Work Order ID 142898

DESIGN #	DRAWN BY CP	DART AEROSPACE LTD HAWKESBURY, ONTARIO, CANADA	
CHECKED #	APPROVED #	DRAWING NO. D3166	REV. A SHEET 1 OF 1
DATE 02.07.10		TITLE BASKET HOOP	SCALE NTS
A	02.07.10	NEW ISSUE	
A1	04.04.08	38+/- WAS 36.0

D3166-1 BASKET HOOP

DRAWING NO. D3166	TITLE BASKET HOOP	REV A1	DART AEROSPACE LTD ENGINEERING ORDER		D.E.O. NO. D3166-A-2	SHEET NO. 1 OF 1	SCALE NTS
DRAWN AJS	CHECKED <i>[Signature]</i>	MFG. APPR. <i>[Signature]</i>	APPROVED <i>[Signature]</i>		DE APPR. <i>[Signature]</i>		
DATE 08.12.11	DATE 08.12.15	DATE 08/12/15	DATE 08/12/16		DATE 08.12.16

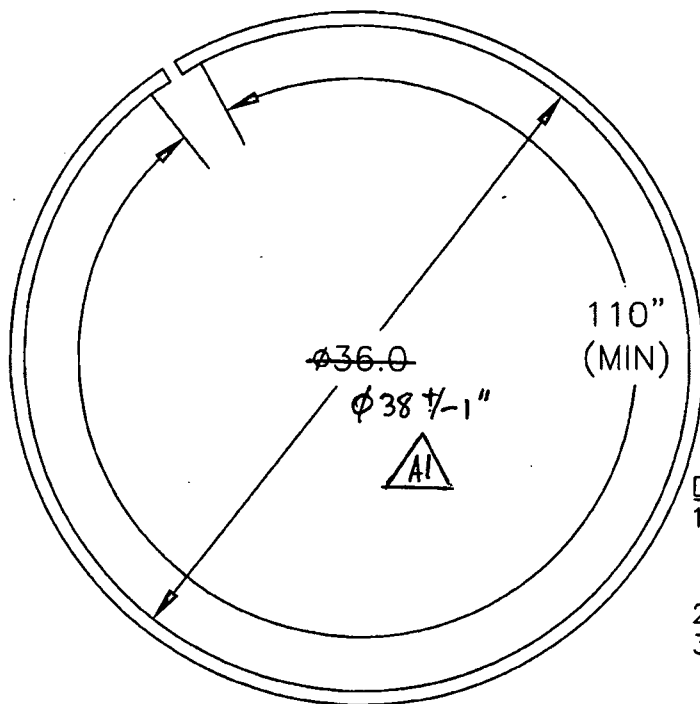
1) MODIFY MATERIAL NOTE FOR D3166-1 AS SHOWN:

WAS:

1) MATERIAL: AISI 304/316 SS SQUARE TUBING,
0.75" x 0.75" x 0.063 WALL, 60.00" LONG
(REF DART SPEC. M304TS0.750W.063)

2) MODIFY MATERIAL NOTE FOR D3166-3 AS SHOWN:

WAS:

1) MATERIAL: AISI 304/316 SS SQUARE TUBING,
0.75" x 0.75" x 0.063 WALL, 120.00" LONG
(REF DART SPEC. M304TS0.750W.063)

IS:

1) MATERIAL: AISI 304/316 SS, 3/4 X 3/4 X 0.065 WALL SQUARE TUBING,
60.00" LONG
REF. DART SPEC M304TS0.750W.065

IS:

1) MATERIAL: AISI 304/316 SS, 3/4 X 3/4 X 0.065 WALL SQUARE TUBING,
120.00" LONG
REF. DART SPEC M304TS0.750W.065
